CITY OF ALBUQUERQUE

**RE: Office/Warehouse
4000 Ellison St. NE
Conceptual Grading and Drainage Plan
Engineer's Stamp Date: 09/06/19
Hydrology File: D17D074**

From: Nicole Friedt <nfriedt@amafca.org>
Sent: Thursday, September 19, 2019 11:32 AM
To: Scott McGee; Jeremy Mechenbier
Cc: Brissette, Renee C.; Jeffrey Willis
Subject: RE: 4000 Ellison G&D Plan
Attachments: 112-19A 4000 ELLISON_CIVIL-stamped12.pdf

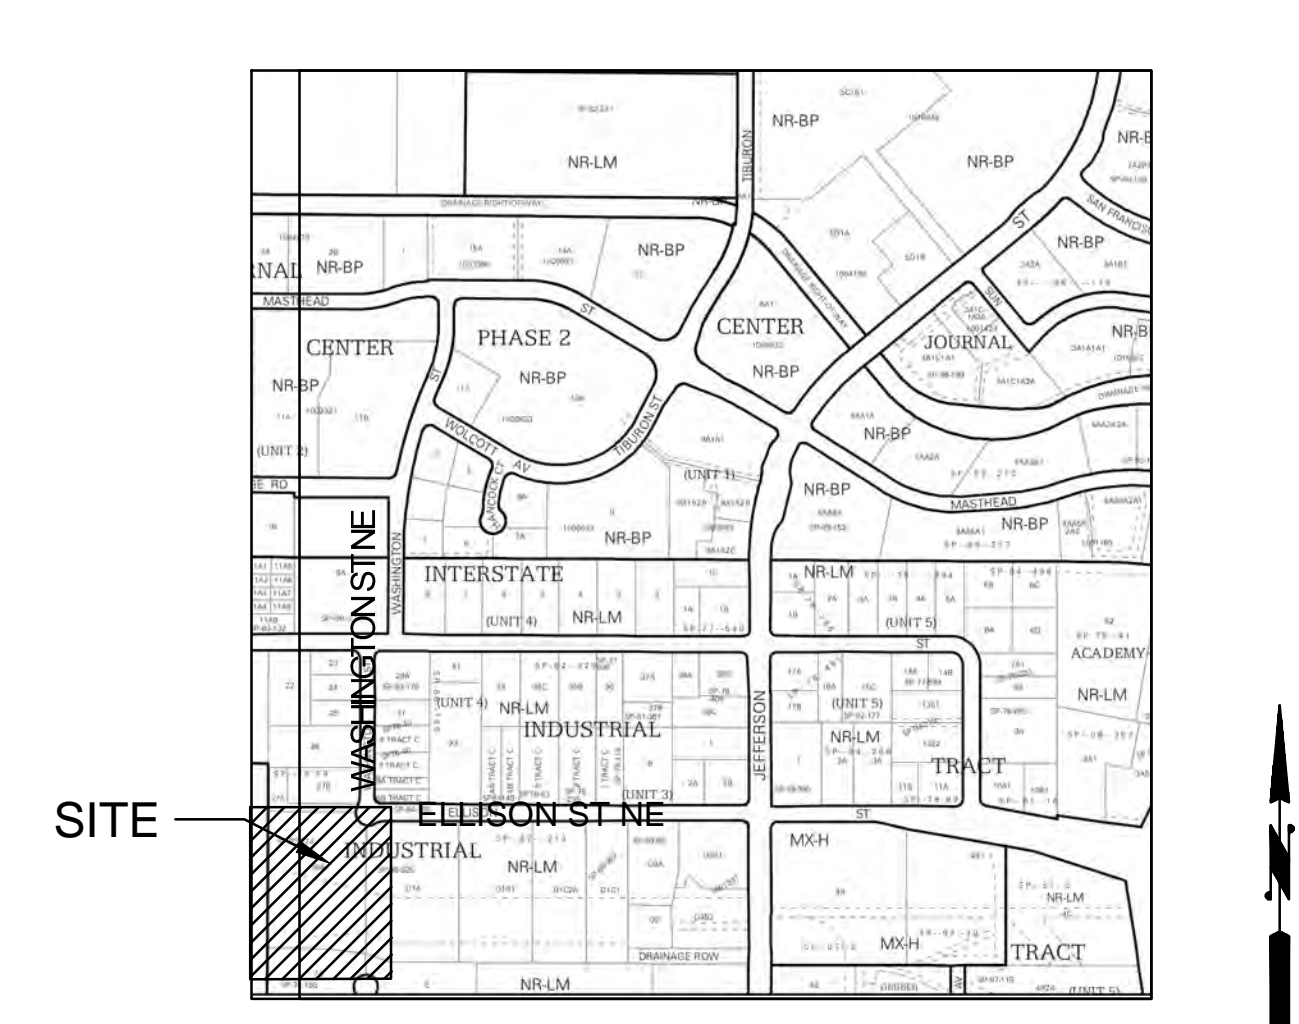
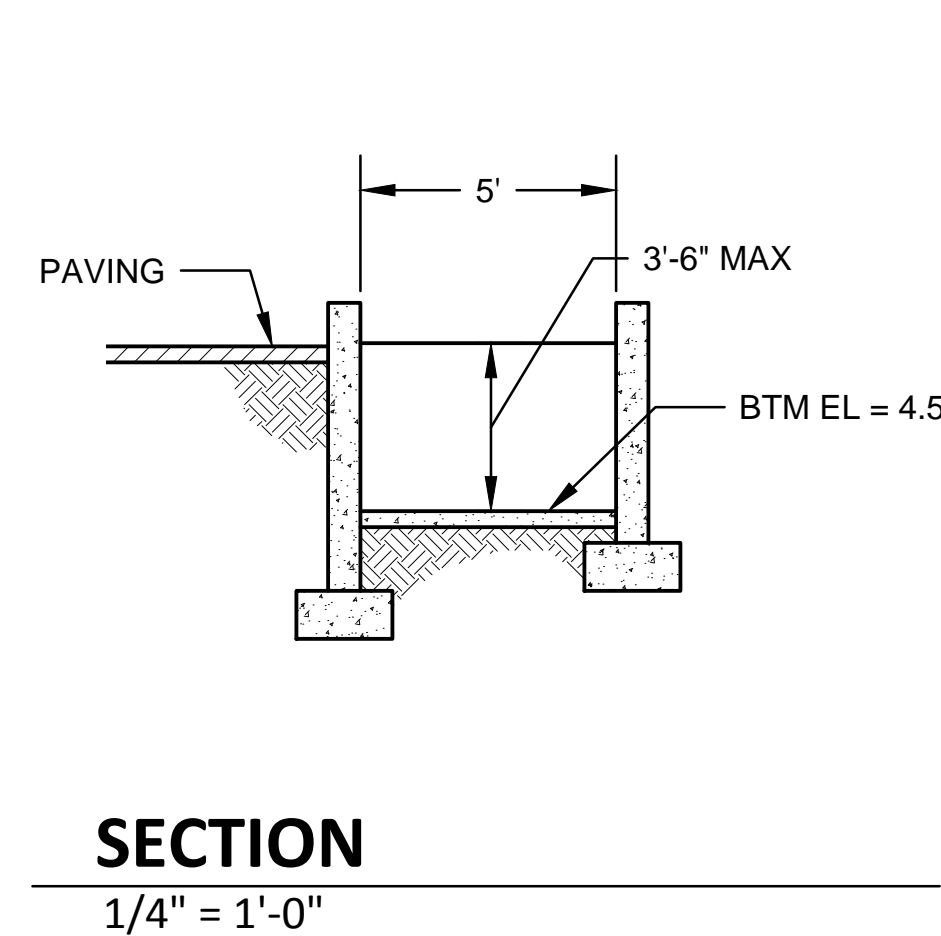
AMAFCA has no further comments on the plan with engineer's seal date of 9/6/19 as attached.

The drainage easement must be modified to encompass the AMAFCA access changes as shown. Also, a license will be required for the construction of the concrete rundown and grading within the modified drainage easement limits.

The area of the AMAFCA maintenance road grading is now shown 'flat' from the channel edge to a point 15' from the channel edge.
